# PRODUCT CHANGE NOTIFICATION

### Bourns® Model CDSOT23 Series TVS Diodes *Additional Assembly and Test Manufacturing Location*

## Typical Part Marking

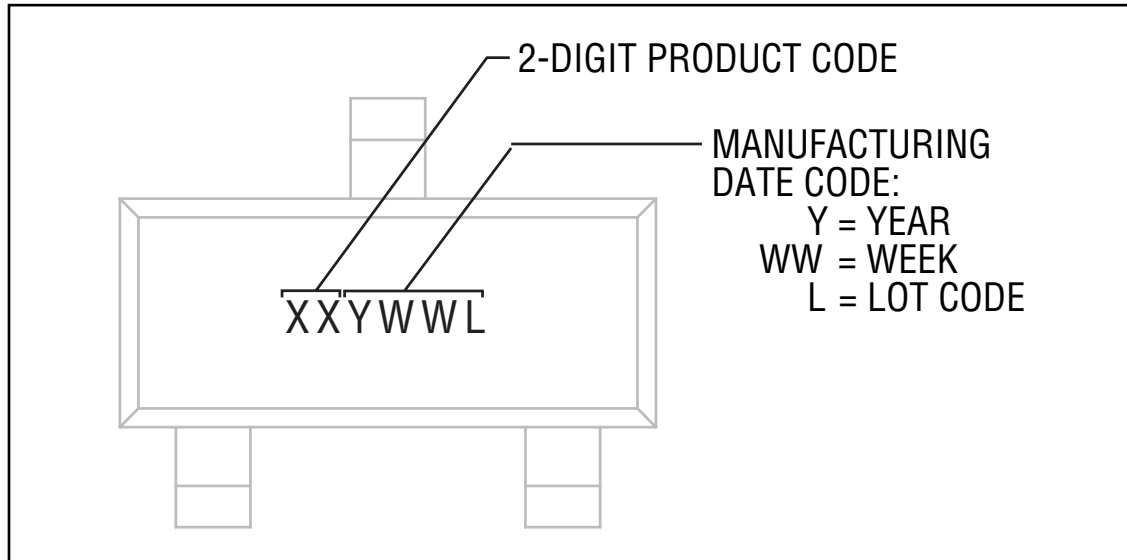
The part marking will be used to identify units produced at the new assembly and test manufacturing site. The lot code (L) of the new site will follow alphabetic characters while the current site will continue to use numbers.
